MANDATORY**MEL-79-01****TITLE**

OIL - TRANSMITTAL OF CONTINENTAL AEROSPACE TECHNOLOGIES CSB07-1A CONNECTING ROD
PISTON PIN BUSHING INSPECTION

CONTINENTAL AEROSPACE TECHNOLOGIES™
CRITICAL SERVICE BULLETIN

SUBJECT: Connecting Rod Piston Pin Bushing Inspection
PURPOSE: Provide inspection instructions for the connecting rod piston pin bushing
COMPLIANCE: At each cylinder removal or anytime piston pin bushing material is identified during routine maintenance

Figure 2. 1000 Micron Stainless Steel Oil Strainer

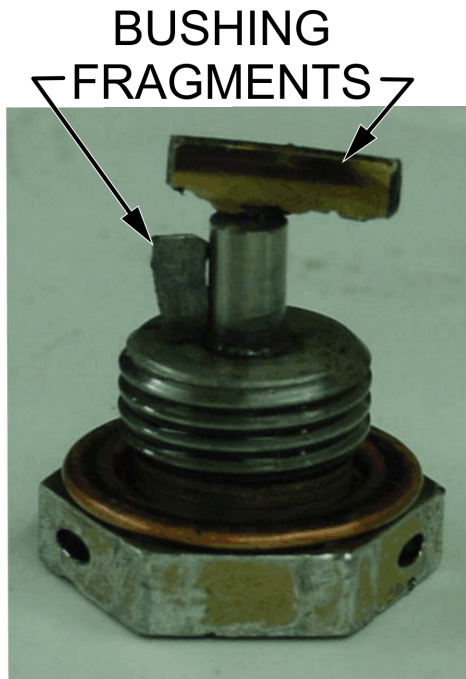
1. Perform the oil change at the next scheduled interval according to the instructions in M-0, Section 6-4.8.
 - a. Rather than drain the oil into catch basin and try to strain the spent oil through a paper filter, Continental recommends the following enhanced instructions:
 - 1) Place a pre-cleaned catch basin beneath the oil sump drain.
 - 2) Position a 1000 micron or less (approximately 0.040" or less) mesh screen in the catch basin to strain the oil sump contents. The 1000 micron stainless steel oil strainer (part number 2000) shown in Figure 2 is designed to fit the opening of a standard 5 gallon bucket. It is available for purchased from Arborfab.com. Arbor Fabricating, 14030 Tuttle Hill, Milan, MI 48160. (734) 626-5864.
 - b. Rinse the excess oil residue from the screen, retaining any fragments, particles, or sediment in the screen for analysis.

Figure 3. Typical Indications of Bushing Fragments

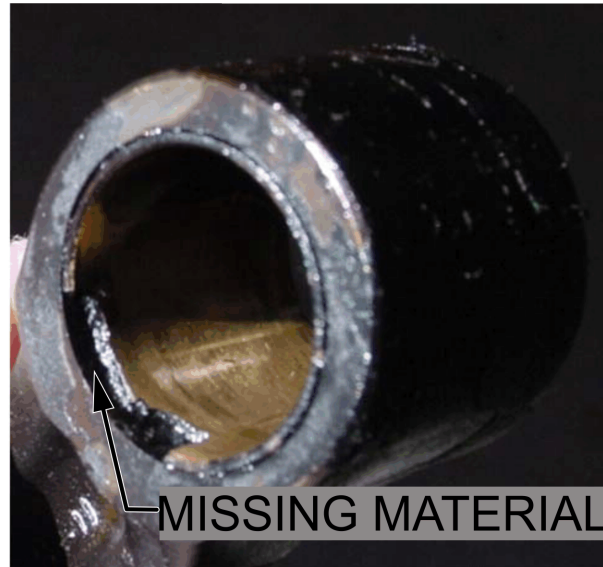
If piston pin bushing material (see Figure 3) is recovered from an engine, remove the cylinders, pistons, and piston pins (no more than two cylinders at a time) to inspect the connecting rod piston pin bushings. In addition, the piston pin bushing must be inspected for condition each time a cylinder is removed for any reason.
